**SAN FRANCISCO UNIFIED SCHOOL DISTRICT
2011 PROPOSITION A BOND PROGRAM
SOTA-AAS HIGH SCHOOL
MODERNIZATION**

ADDENDUM NO. 2

Date: Dec. 10, 2014
SFUSD Proj. No.: 11522
DSA App. No.: 01-114087

AD2.1

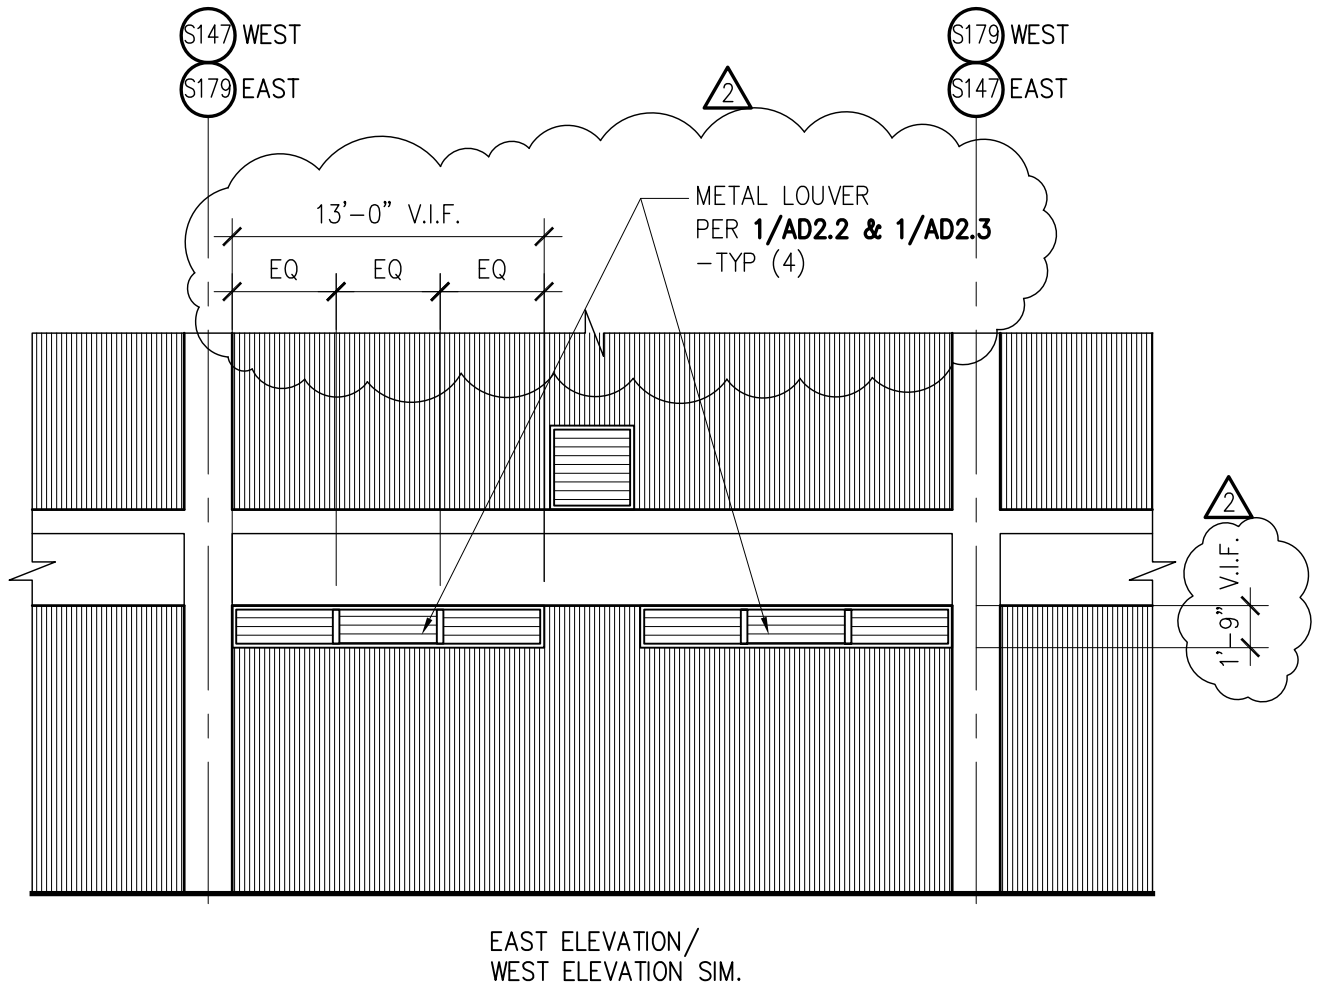
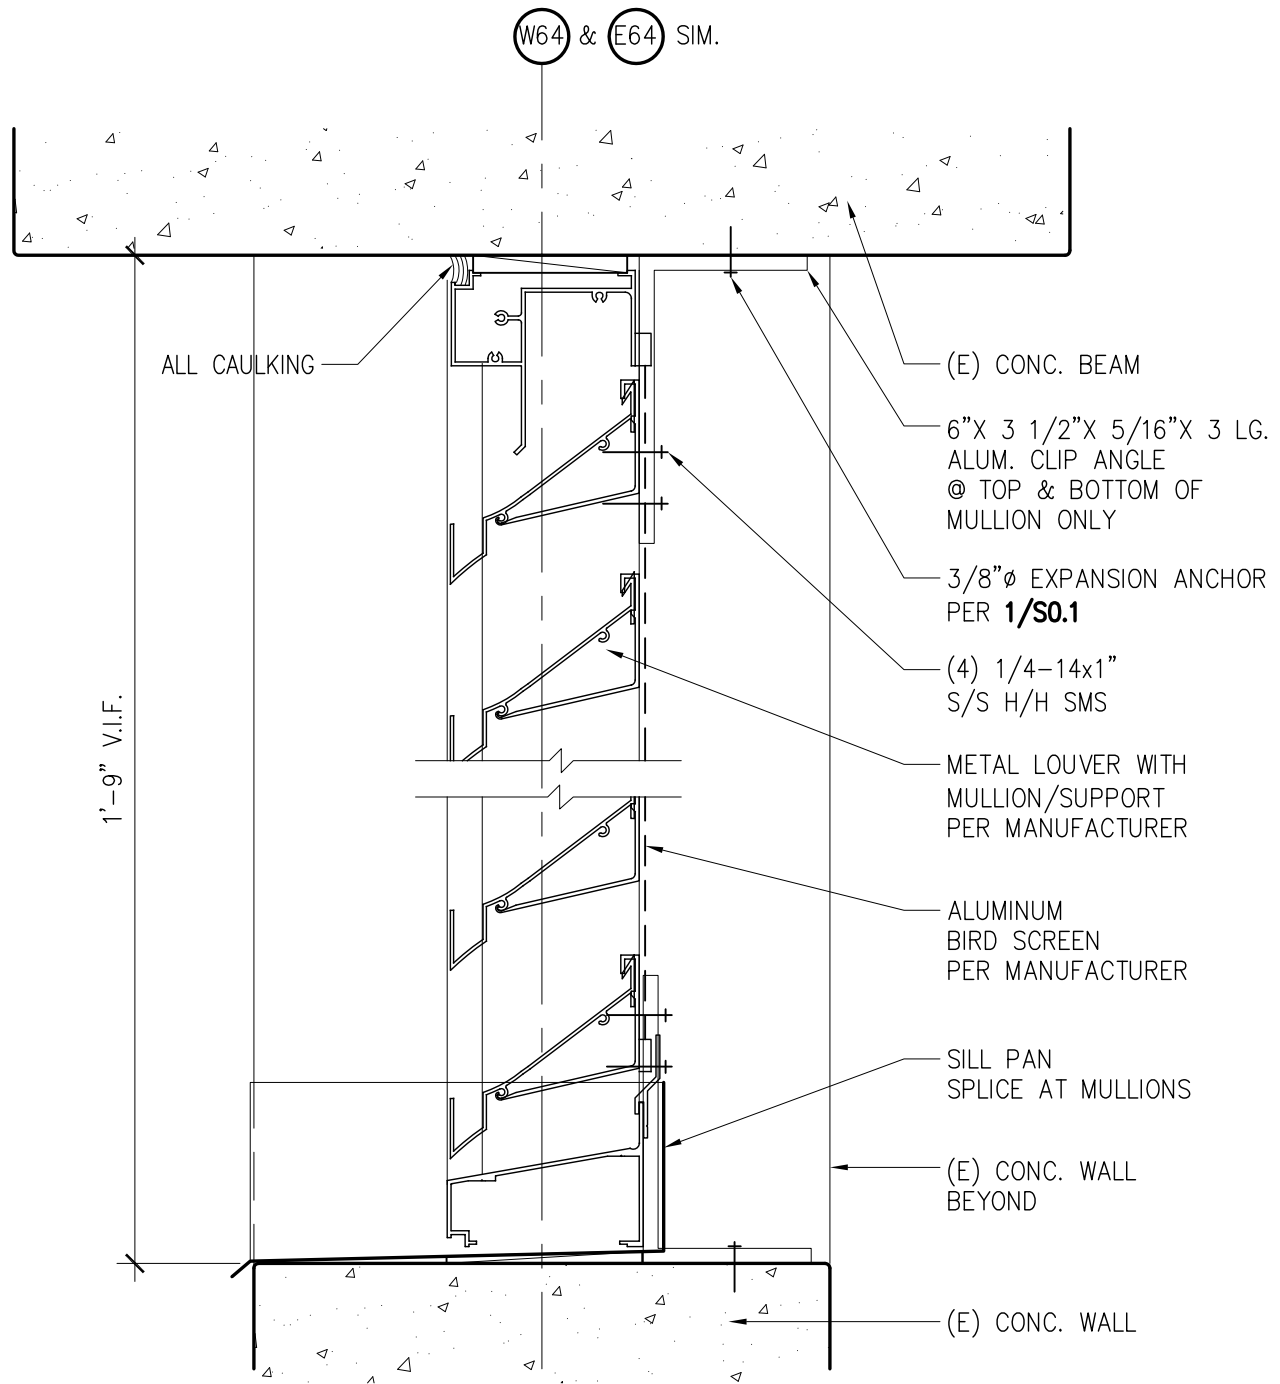
AD2.13 Sheet A-B3.1, Bldg B Gymnasium Bldg Exterior Elevations Improvement.

Detail 2, East Elevation / West Elevation Similar: Provide louvers where existing louvers are removed, as shown on attached drawing **AD2.1**, and louver detail **AD2.2** and **AD2.3**.

SKP-1

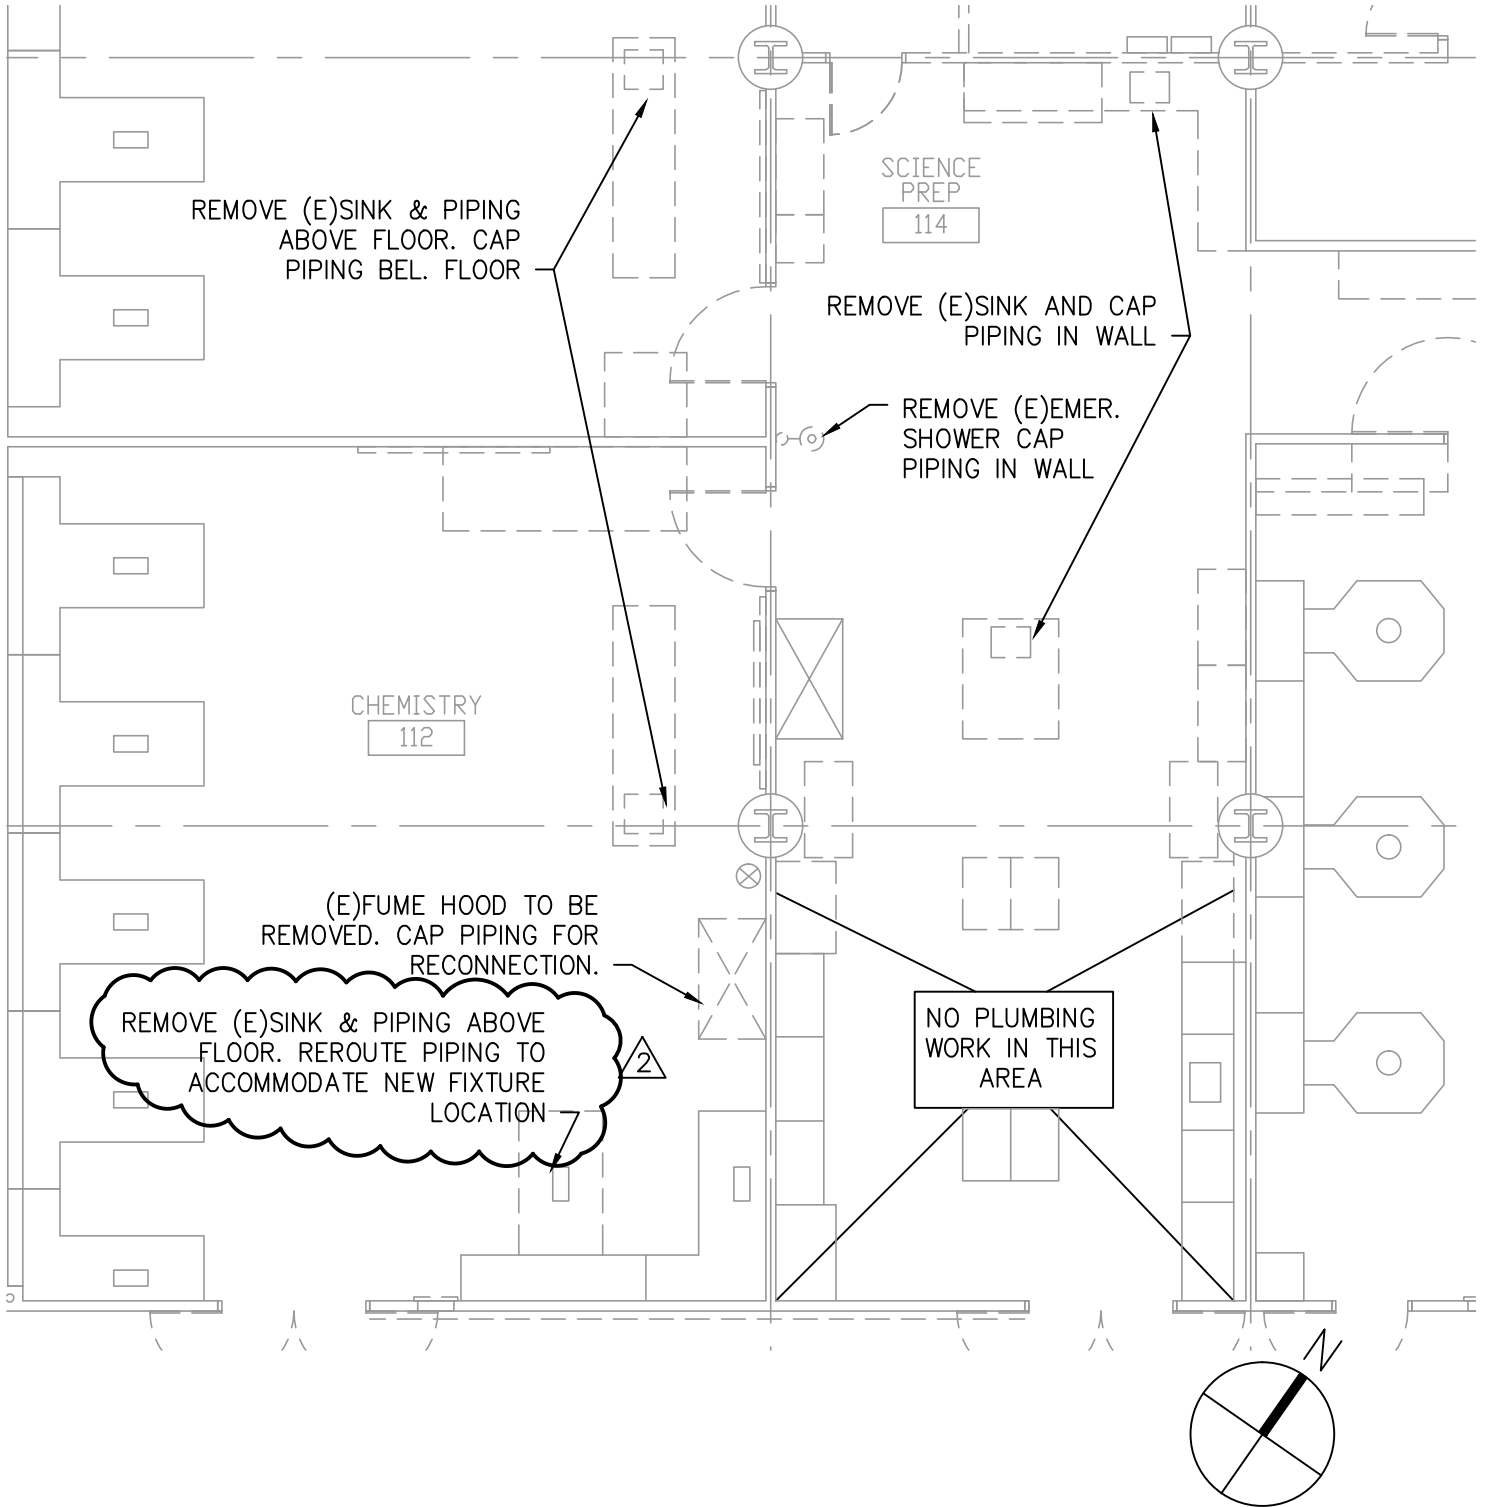
AD2.18 Sheet P-A2.1D, Building A Plumbing First Floor Demo Plan – Part 1.

- A. Revise plumbing demo at Physics Room 135 and Chem Stor Rm 114A as shown on attached drawing **SKP-1**.
- B. Revise plumbing demo at Chemistry Room 112 as shown on attached drawing **SKP-2**.
